Customer Name:		Gallien-Krueger		Current Rev #:		A1		New ECO Rev #:		A2	
Model:		Backline 250, 600, 115 Combo,		Distribute To:				Page:		1 Of: 2	
Assembly Description:		and 210 Combo		Originator:		Enrique Hernandez					
Assembly Numbers:		206-0181-A		Approved by:							
				Effective Date:		2/15/2005					
Effective				Document Update				Date		Initials	
<input checked="" type="checkbox"/>	All in Process	<input checked="" type="checkbox"/>	Next Buy	<input type="checkbox"/>	Artwork						
<input type="checkbox"/>	All in Service	<input checked="" type="checkbox"/>	Next Production Run	<input type="checkbox"/>	Assembly Dwg.						
<input checked="" type="checkbox"/>	All in Stock	<input type="checkbox"/>		<input type="checkbox"/>	Board Artwork						
Beginning Serial Number:				<input checked="" type="checkbox"/>	BOM						Noli
Reason For Change				<input type="checkbox"/>	Control Form						
Pre-Amp revoiced to sound more like the 400RB-IV.				<input checked="" type="checkbox"/>	Costing						TC

TITLE: BACKLINE 115 PREAMP
DRAWING NO: 406-0181-A
PART NO: 206-0181-A
REV: A2
COMPANY: GALLIEN-KRUEGER
FILENAME: 6181A.SCH

Customer Name:		Gallien-Krueger		Current Rev #:	A2	New ECO Rev #:	A3		
Model

TITLE: BACKLINE 115 PREAMP
DRAWING NO: 406-0181-A6
REV: A6
DESIGNED: P.A.G. 1-31-01
DRAWN: P.A.G. 7/7/98
CHECKED: [blank]
REVISED: [blank]

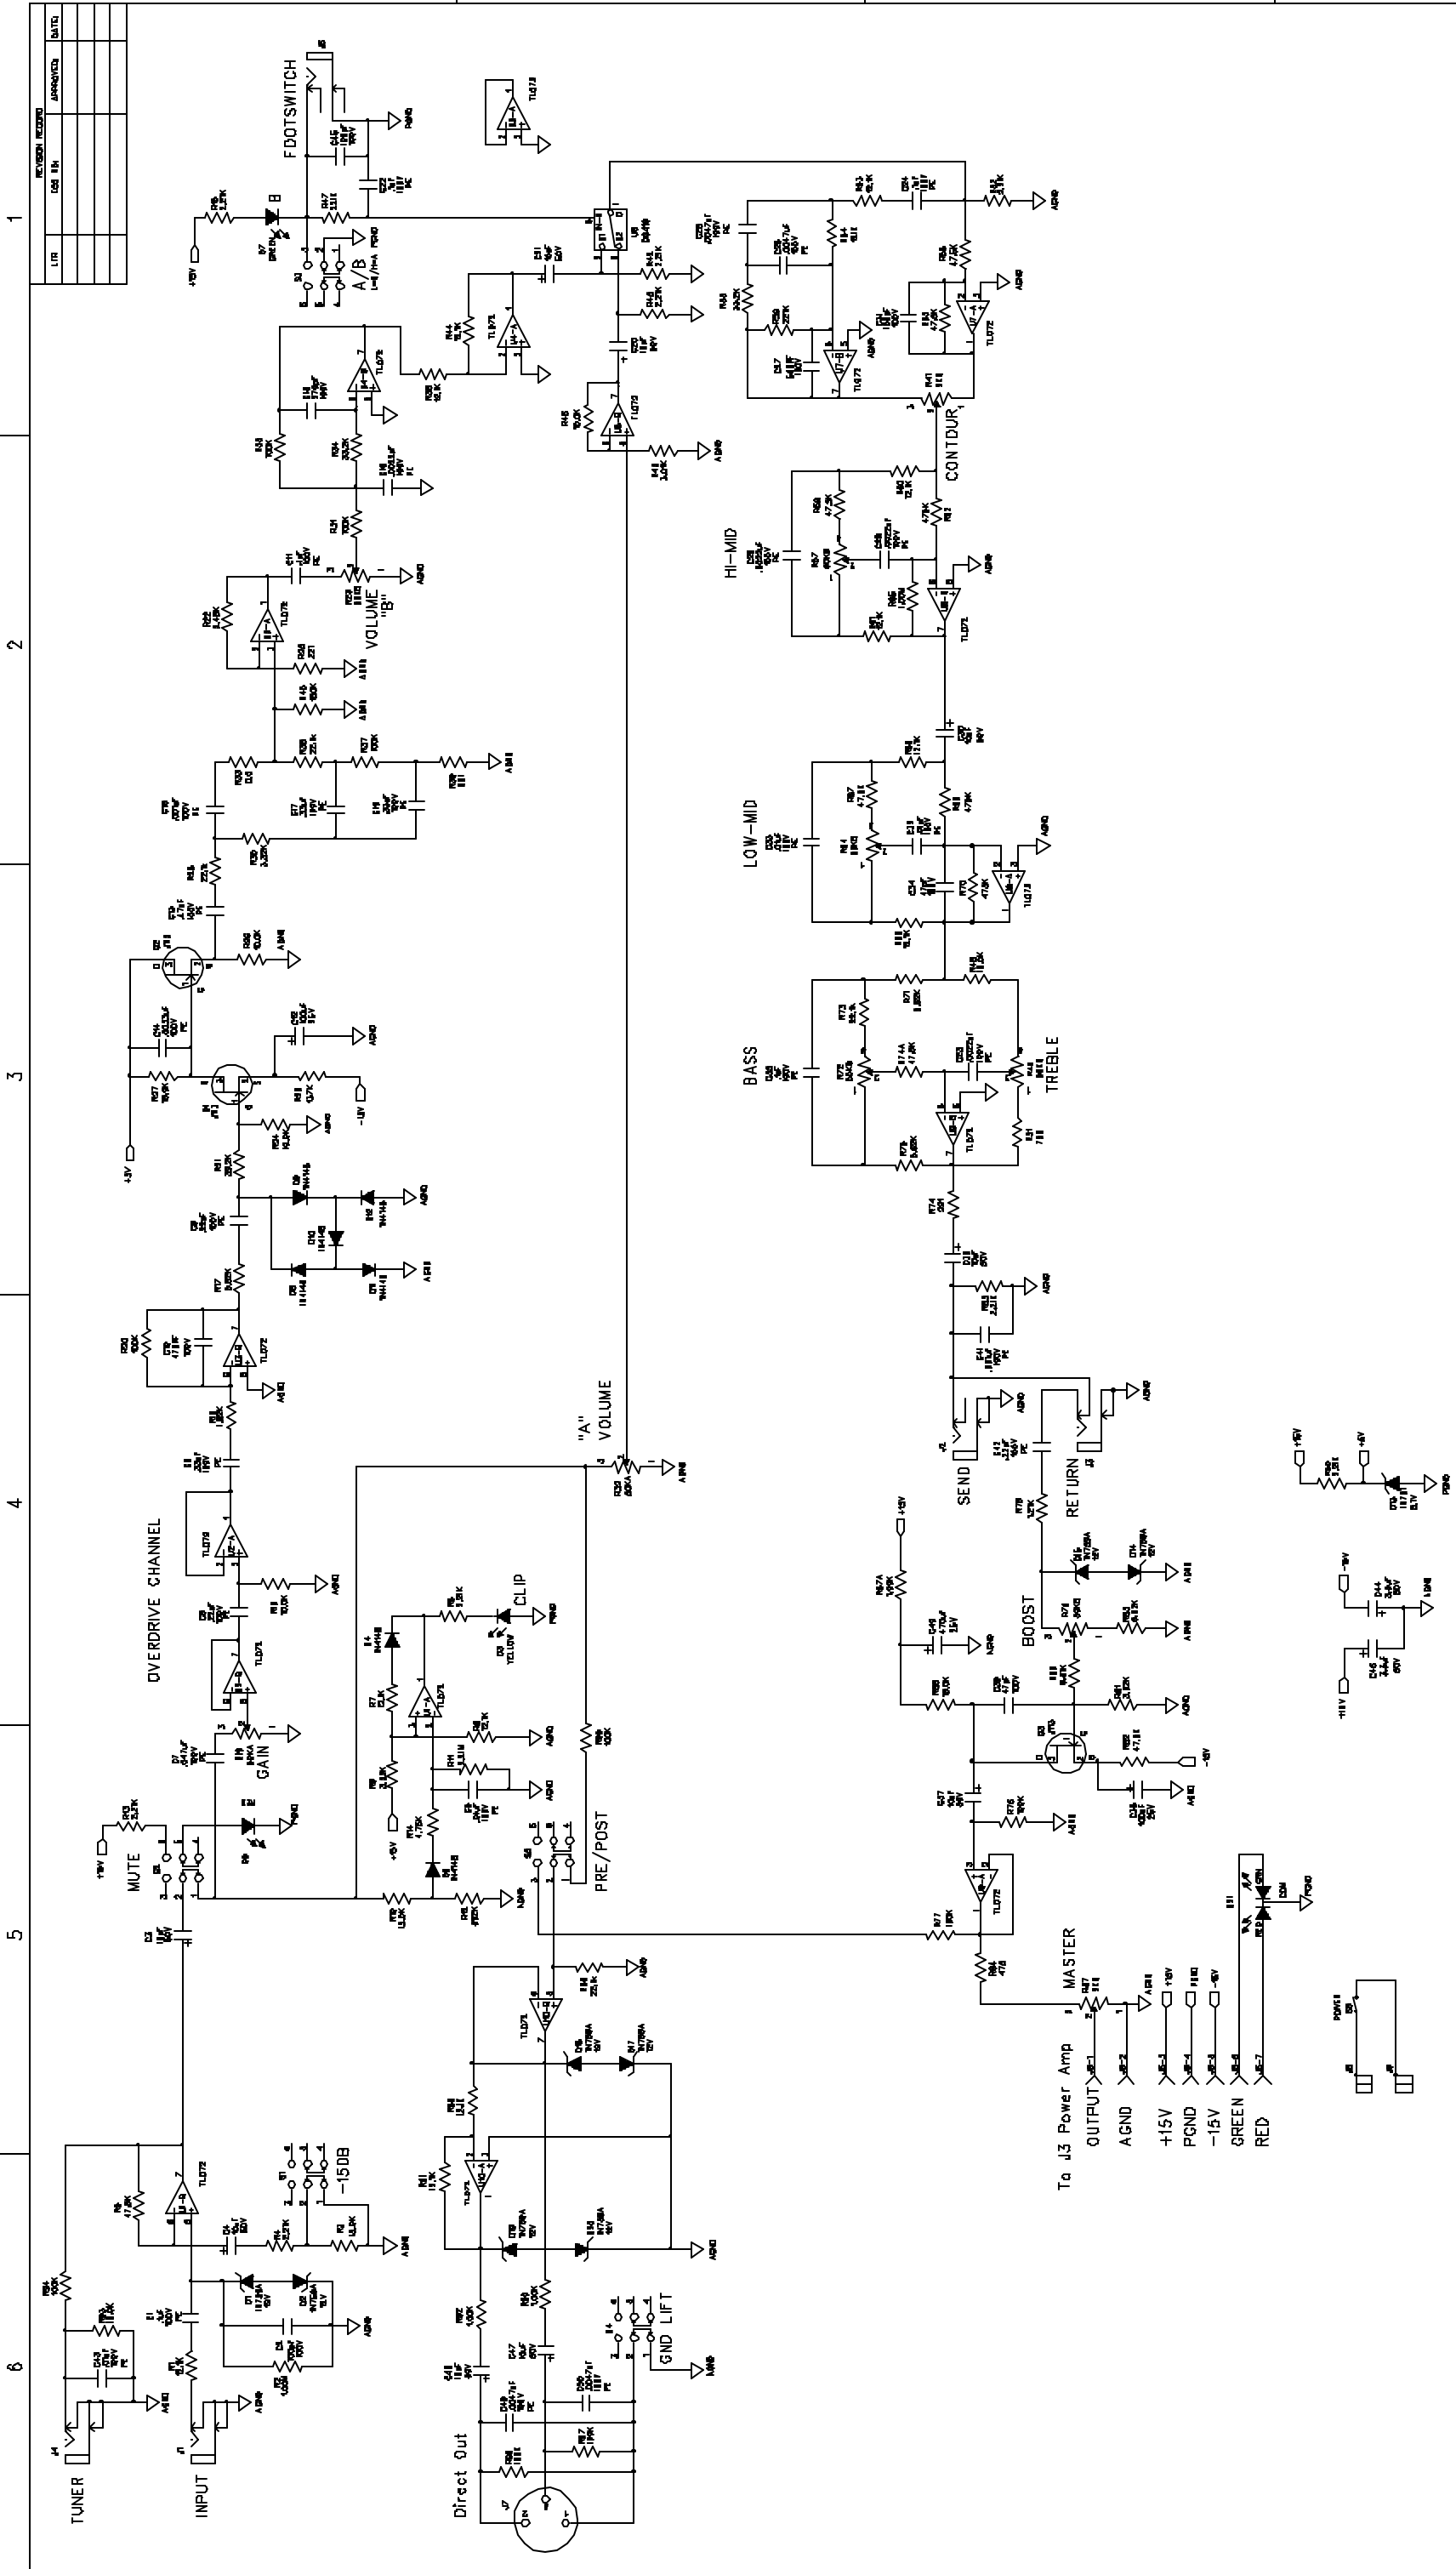
1. To mute the pre-direct out signal, R95 is connected to pin 3 of R32.		<input checked="" type="checkbox"/> Costing			TC
		<input type="checkbox"/> Fab Drawing			
		<input type="checkbox"/> Inspection Proc.			
		<input checked="" type="checkbox"/> Part Master File			Noli
		<input checked="" type="checkbox"/> Schematic			RAG
		<input type="checkbox"/> Service Manual			
		<input type="checkbox"/> Test Procedure			
		<input type="checkbox"/>			
		<input type="checkbox"/>			
Other Affected Assemblies					
209-0180-A, 303-0180-A, 303-1180-A, 303-2180-A					
<input type="checkbox"/> Continued on ECO Supplement Page					
Description Of Change		Distribution		Date	Initials
Update schematic.		<input type="checkbox"/> Accounting			
Update PCB layout.		<input type="checkbox"/> Assembly			
Update BOM.		<input checked="" type="checkbox"/> Customer			
Update Part Master File.		<input checked="" type="checkbox"/> Engineering

NOTES A6:
1. MOVE R80 TO TOP OF R92.
